From: Lasley, Timothy G
Sent: Thursday, July 19, 2018 10:01 AM
To: 'jenniferfeist@murray-enterprises.com'; 'adavies@williamsmullen.com'
Cc: Werner, Jeffrey B; Mess, Camie
Subject: BAR Actions - July 17, 2018 - 815 East High Street

BAR 18-07-03

815 East High Street; Tax Parcel 530197000, 530196000, 530195000, 530194100, 530198000, 530199000, 530200000, 530201000, 530202000

TARLETON OAK
Tarleton Oak, LLC

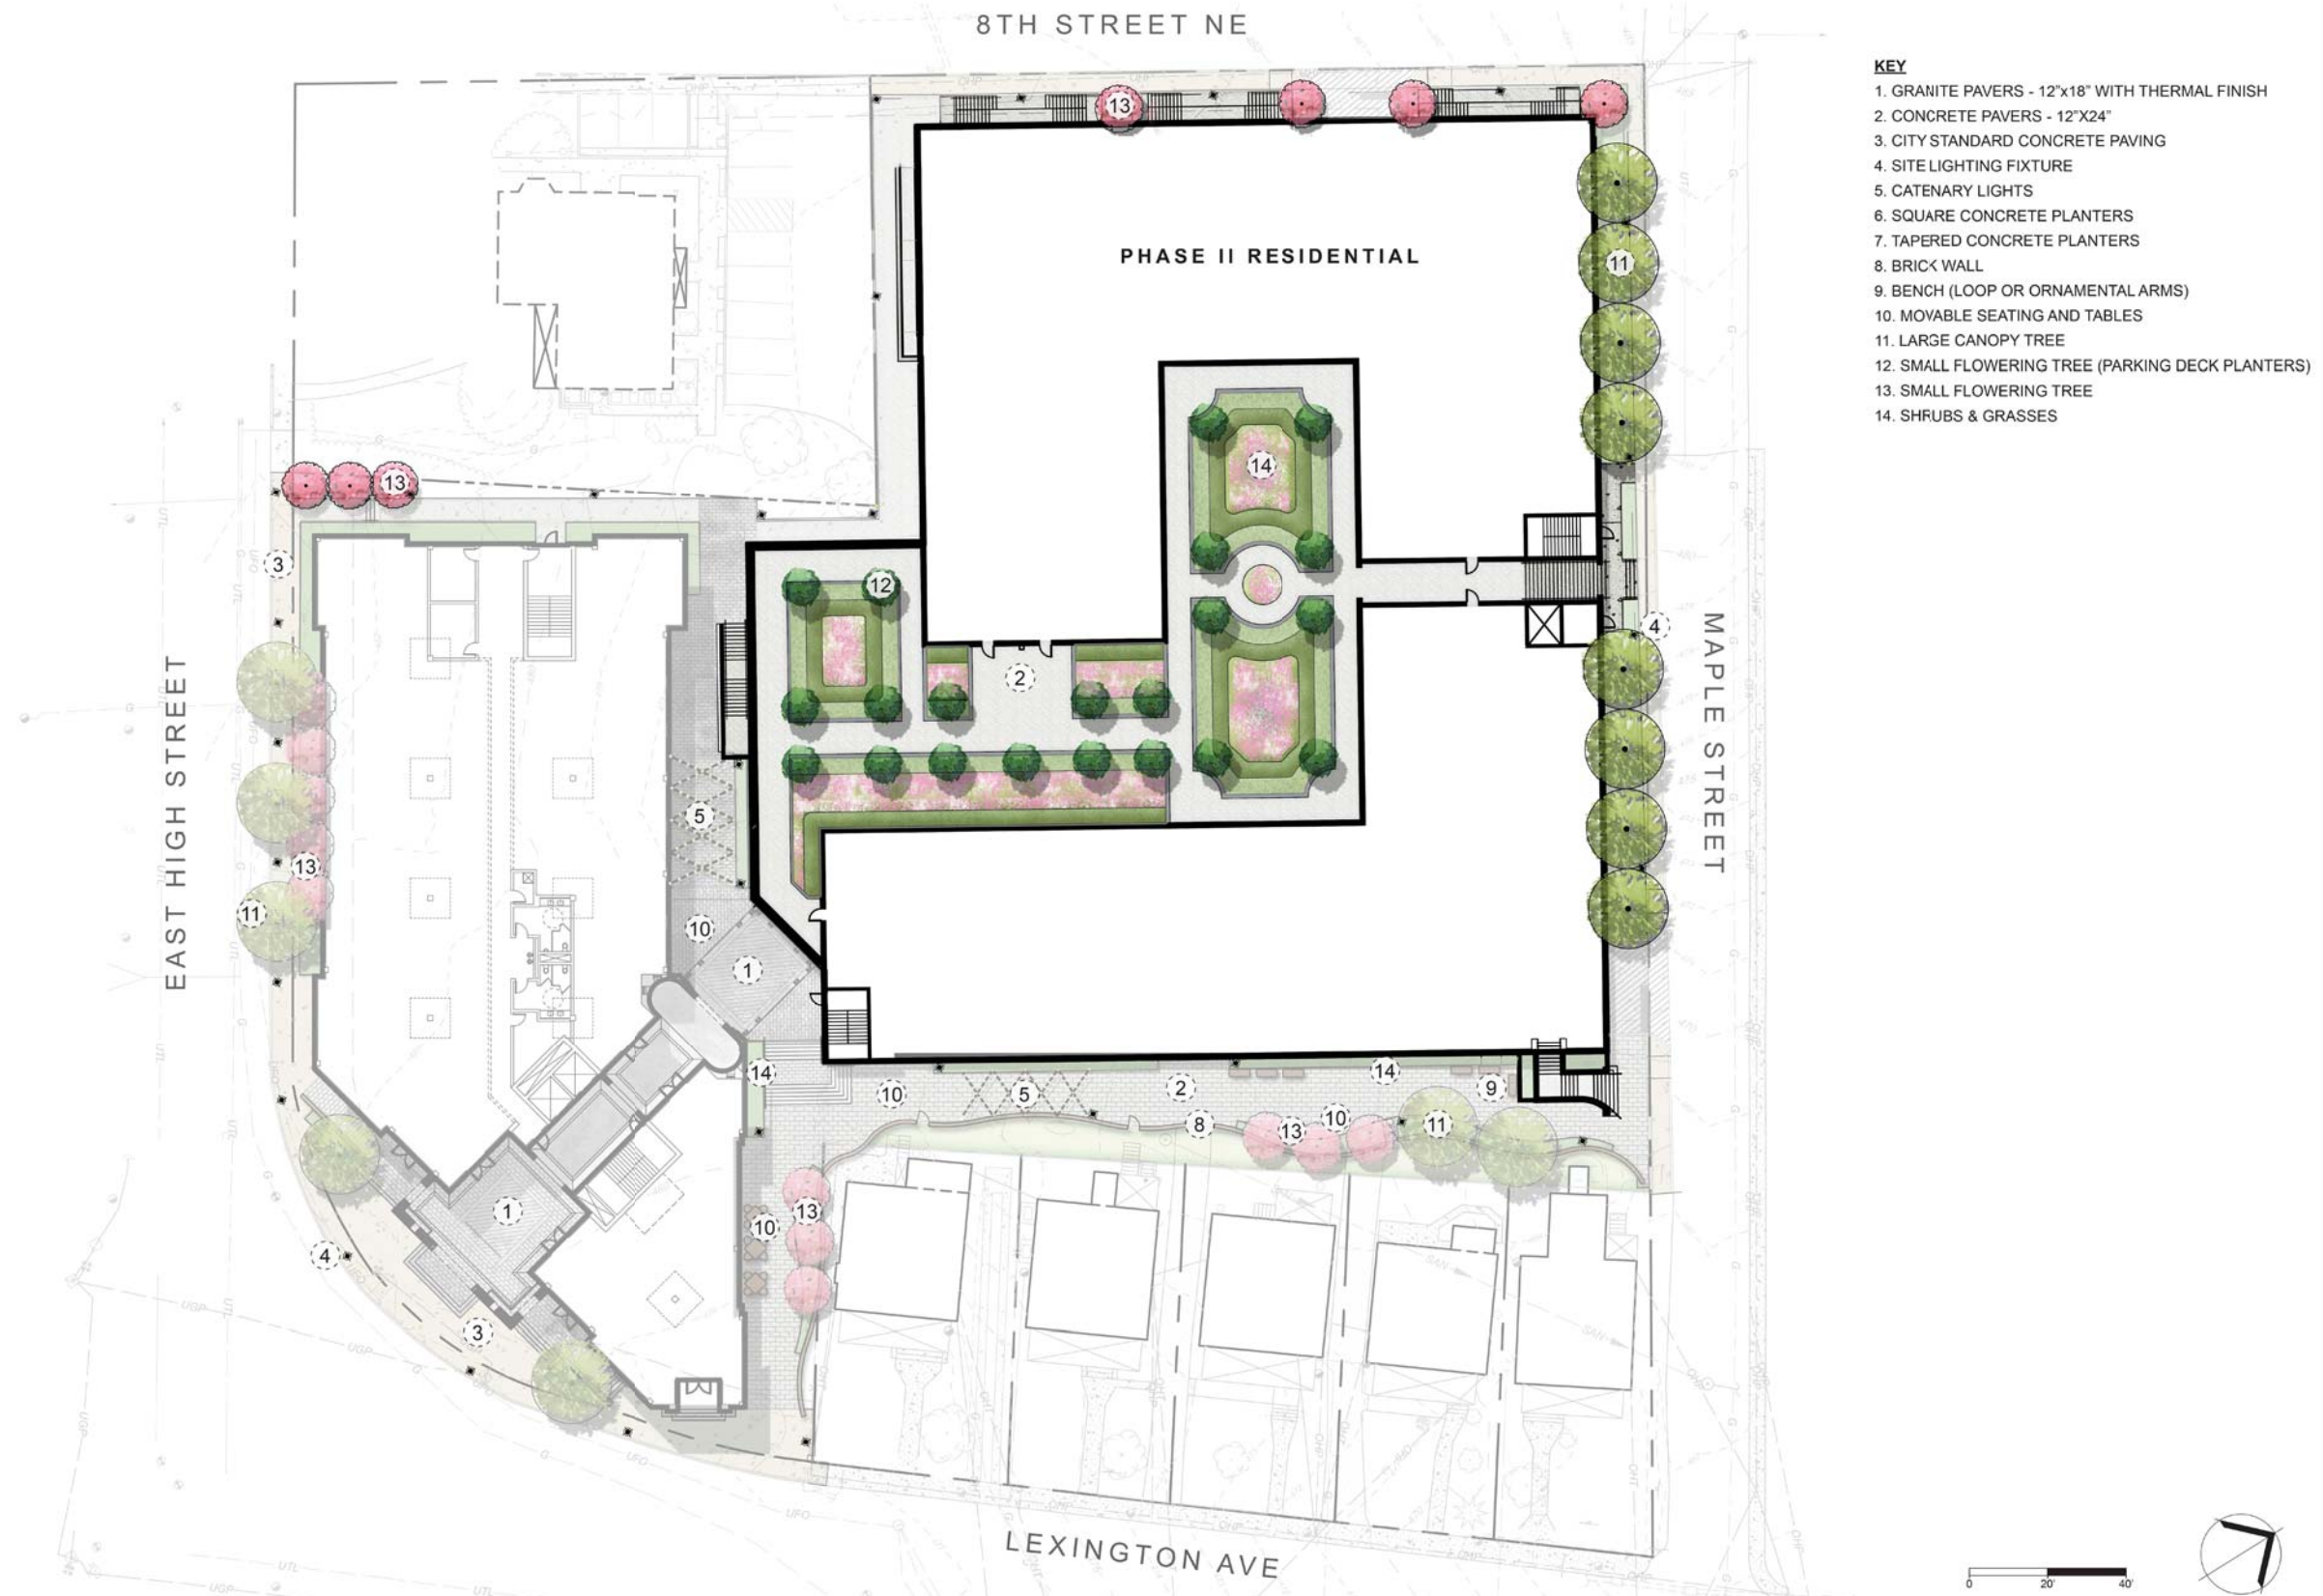
- Add large trees (conforming to the city's tree list) within the space between the back of the five houses on Lexington Avenue and the east facade of the parking/residential structure. (Pages 9 revised and 13 revised.)

- Add vegetation along the walls on either side of the pedestrian walk between the back of the five houses on Lexington Avenue and the east facade of the parking/residential structure. (Pages 9 revised, 13 revised and 18.)

- Note on the plan the proposed tree species
- Address the visibility from the outside of the lighting within the parking structure.

Revised Sheet: Submitted 6/26/2018

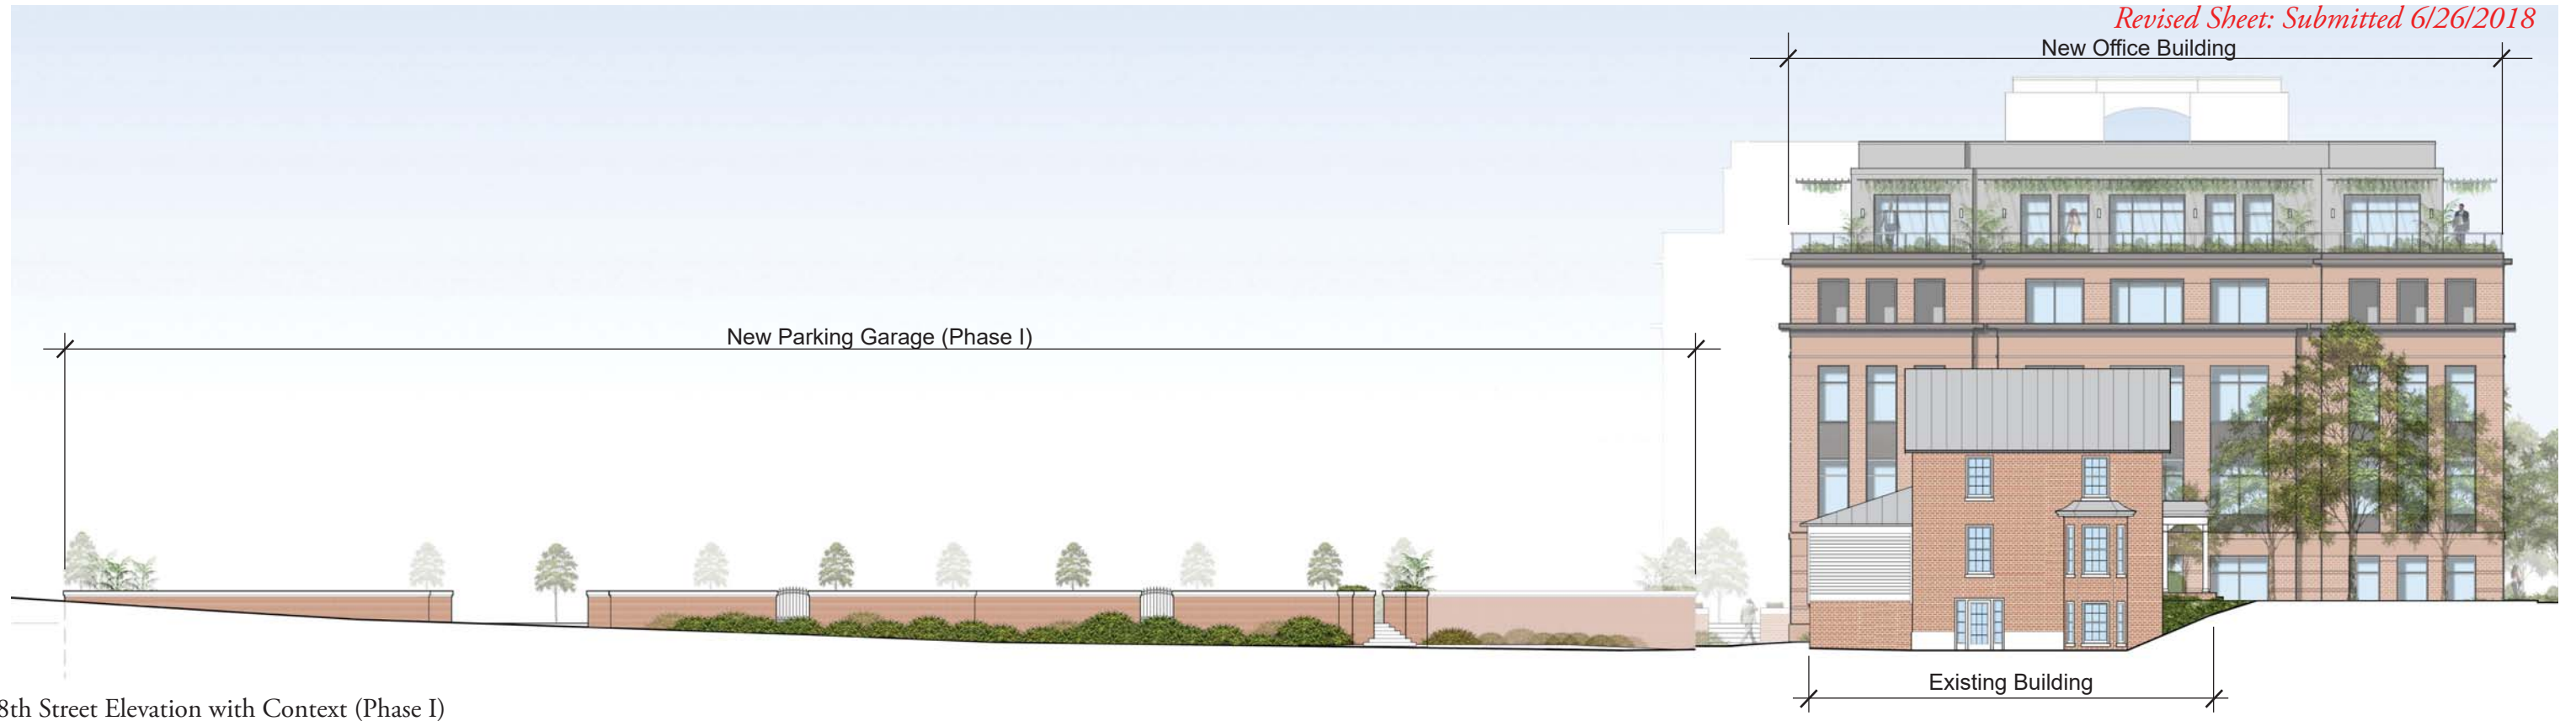
- Along the 8th Street elevation, address the heights of the arched openings [between the staircases], which get shorter from south to north. (Page 14 revised.)

Staff finds that the proposed setbacks for Phase II of this project gives the façade a rhythmic meter. However, staff would like to see dimensions of each setback for all elevations. Staff recommends that the BAR discuss the 8th Street elevation relative to the BAR comments about the project’s relationship to the IPP at 801 East High Street. (See pages 14 and 14 revised.)

Maple Street Elevation with Context (Phase II)

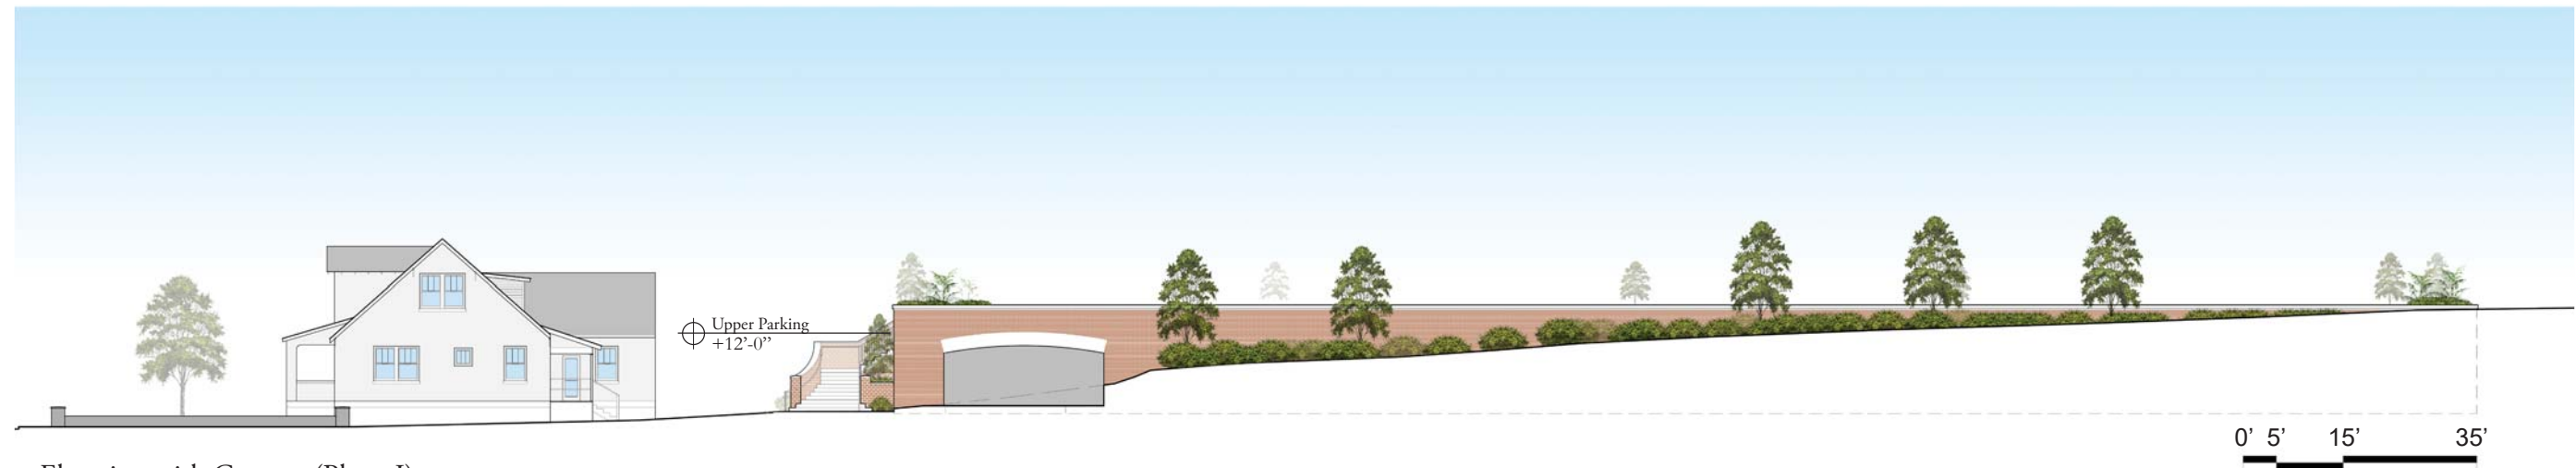
- At the NE corner, address the height of the water table band [from where the grade drops at the arched opening on Maple Street, continuing east and around the corner onto the east elevation]. (Pages 15 revised and 18.)

Staff is generally supportive of the proposed design and materials palette, however the BAR should discuss the appropriateness of the design, materials, massing and height of the two story residential, particularly in relation to the adjacent houses on Lexington Avenue. Clarification is needed on the nature of the wall openings shown at the upper parking level (see sheets 15 revised and 18.)
